Request for City Council Action

| City Planner Licht | City Administrator/Finance Director Flaherty City Engineer Wagner | 4.1 – Great River Centre of Otsego 8 th Addition |

PLANNING REPORT

RE: Otsego – Foss Swim School; Preliminary Plat/Sketch Plan

1 GRADING AND DRAINAGE PLAN
C400

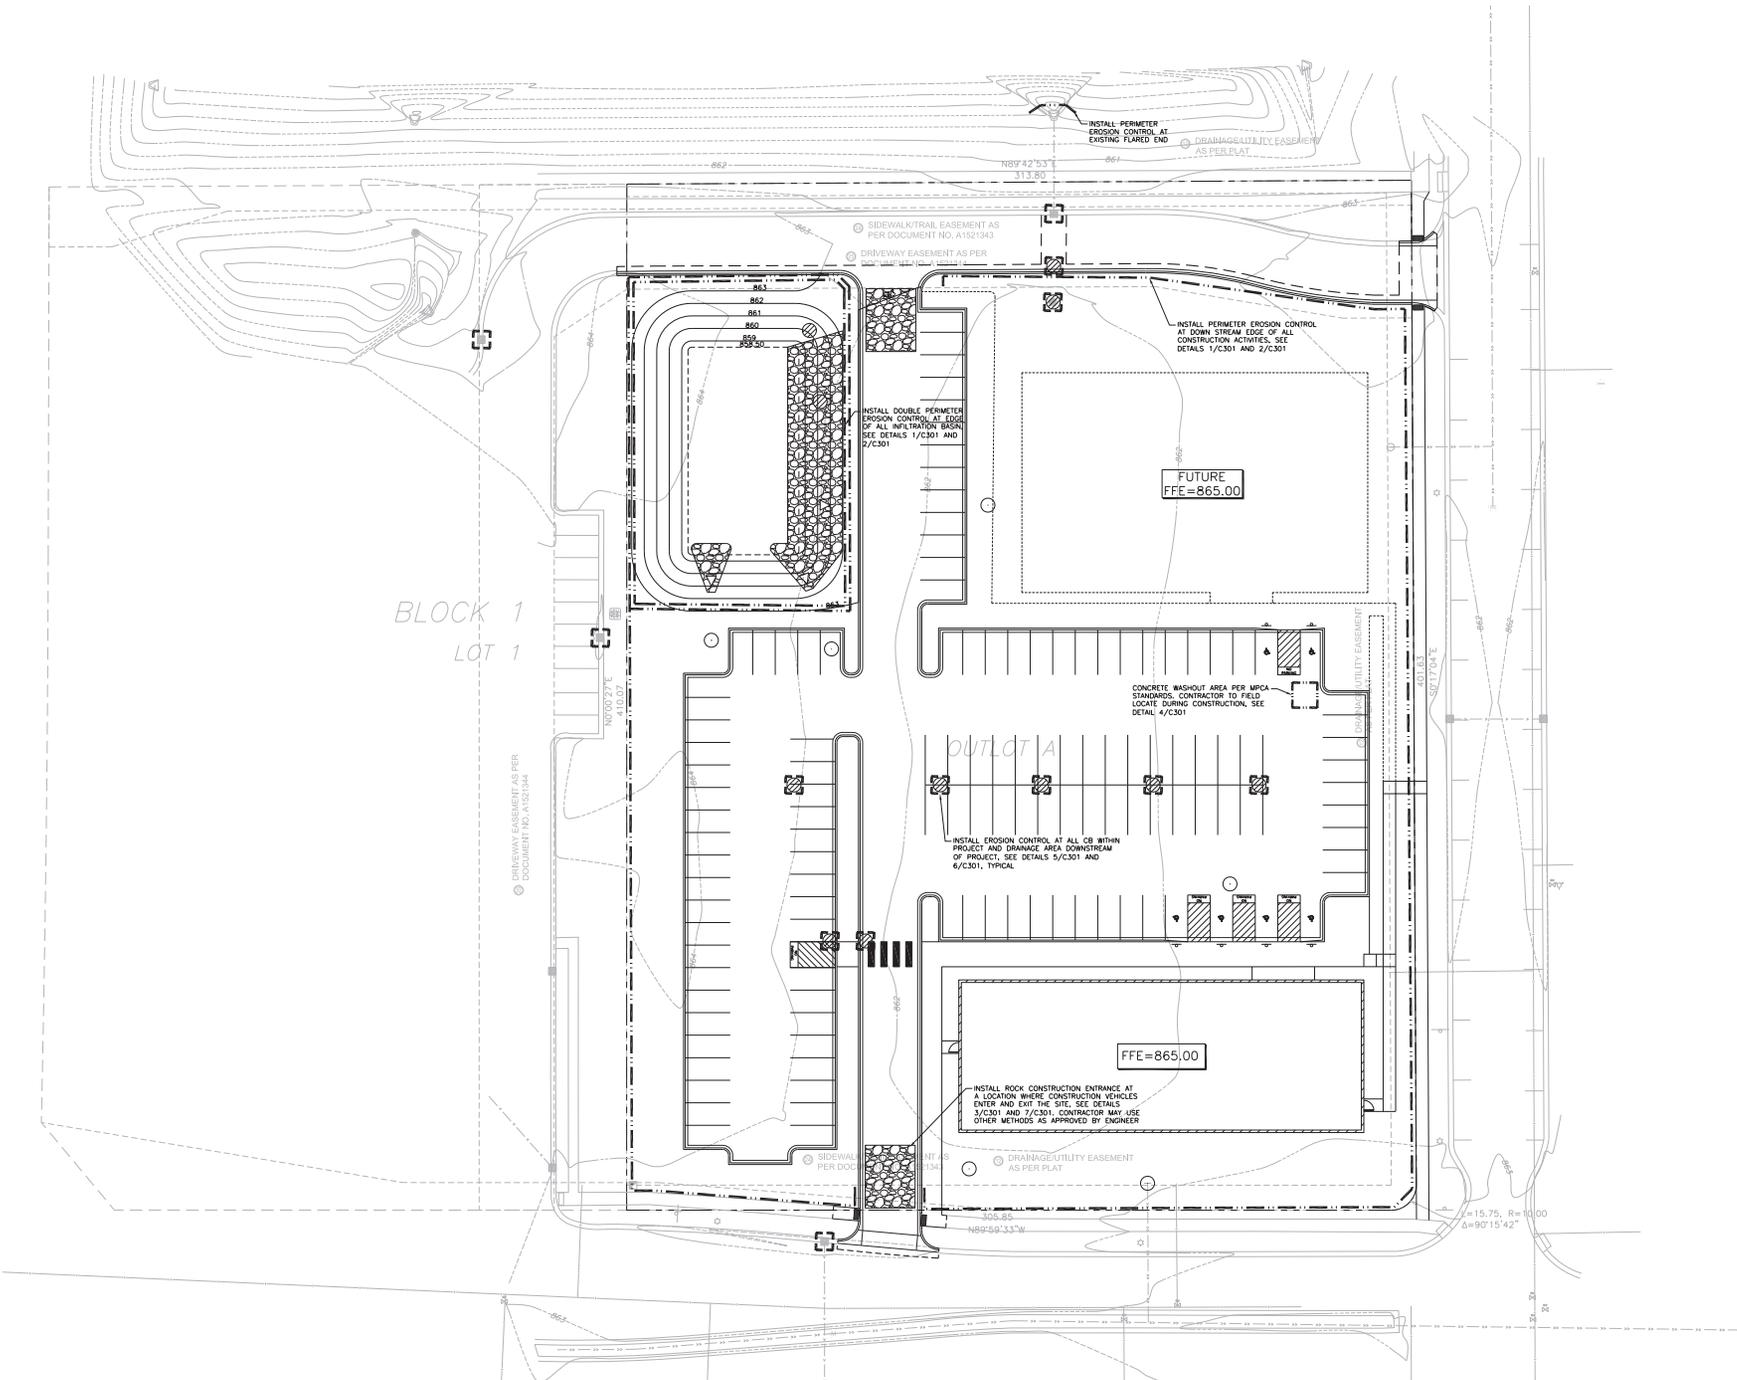
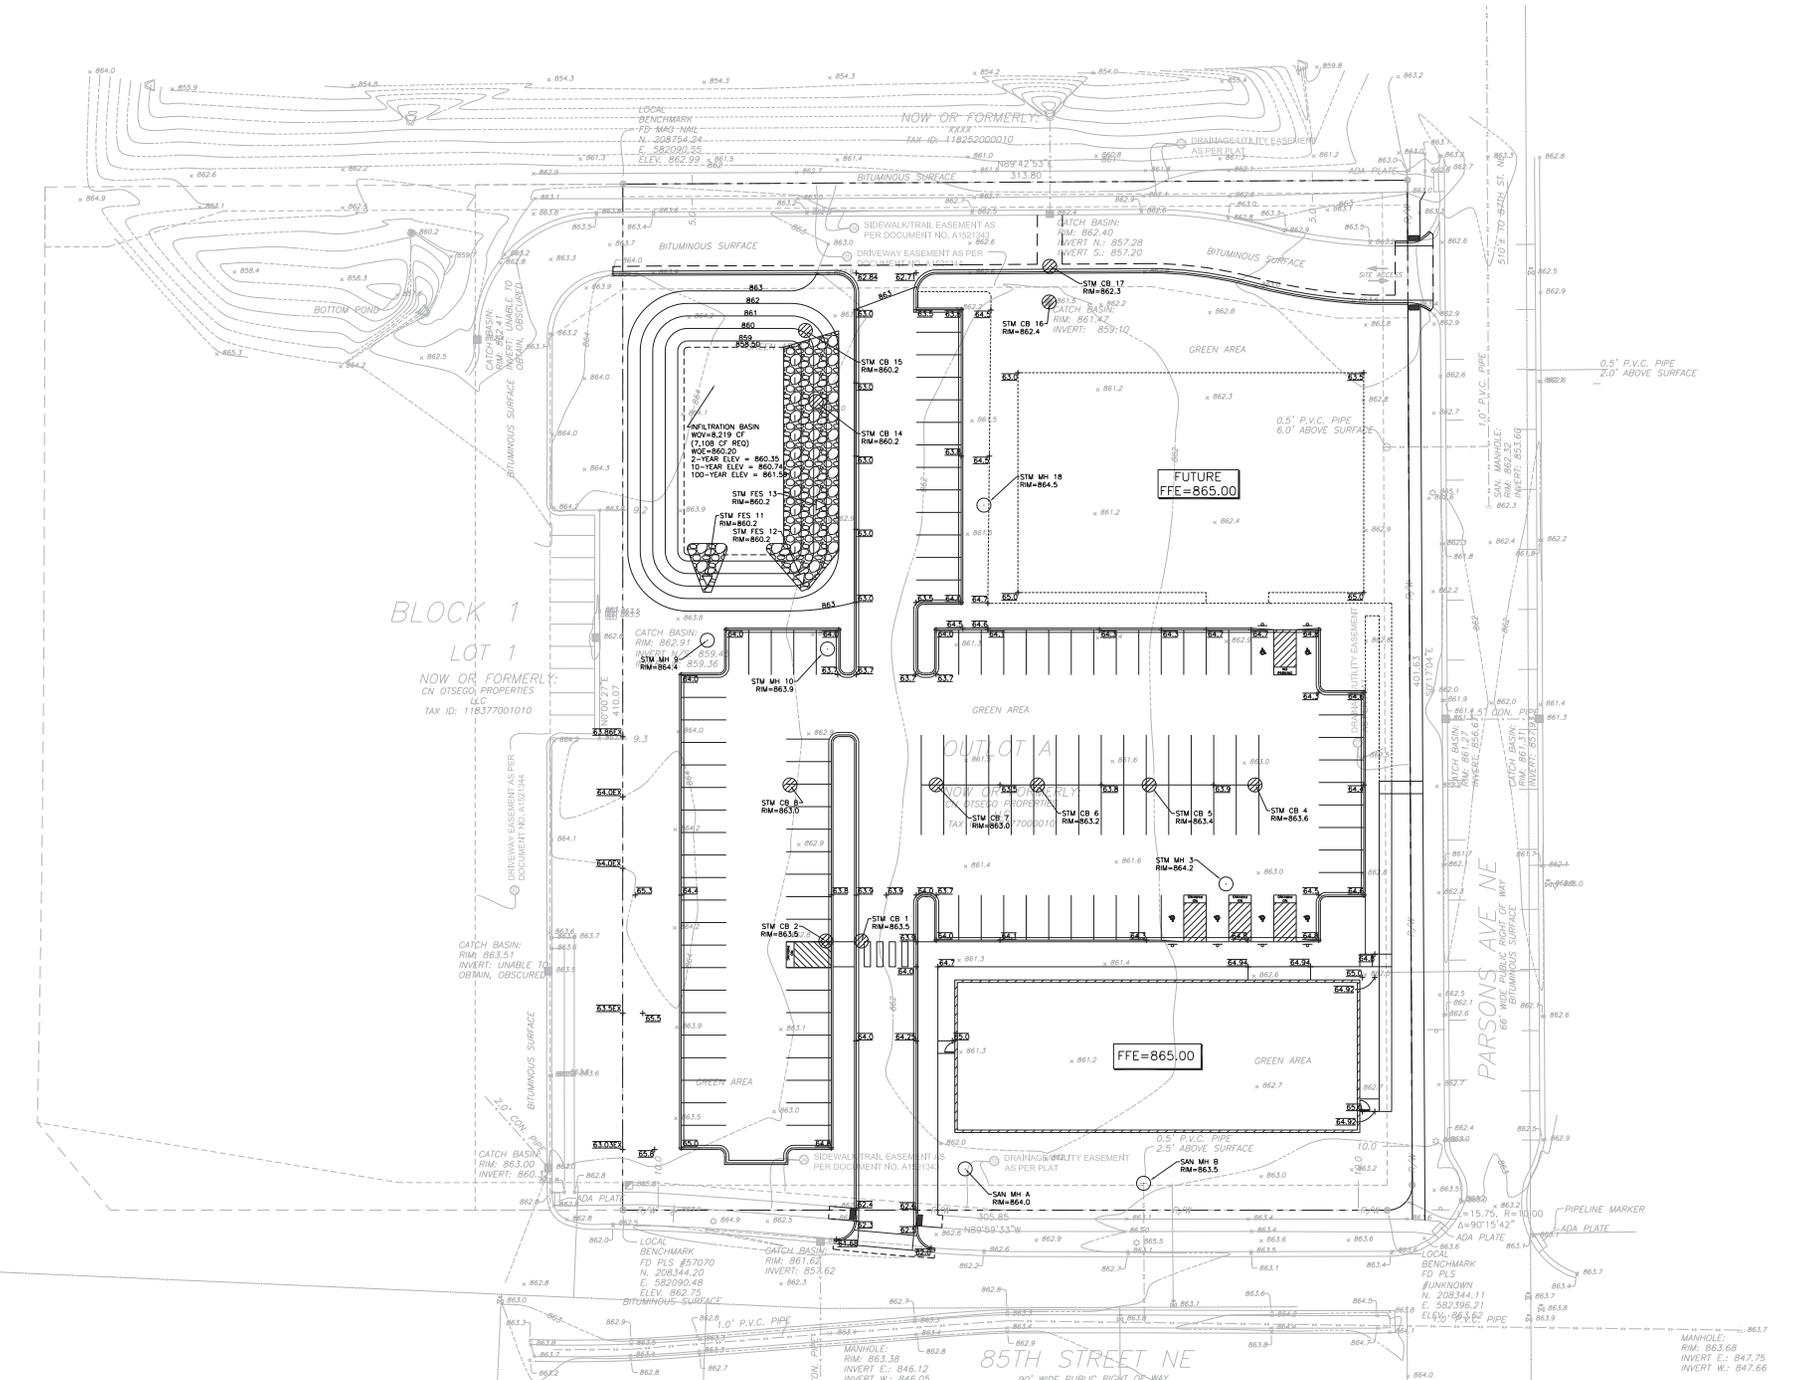
11. Concrete Band (Ribbon Curb) is not allowed. Replace with surmountable standard plate #704, #705 or B6 curb standard Plate #7100H.
12. A catch basin will need to be added and regrade curb for water to flow to the CB west of future building site.
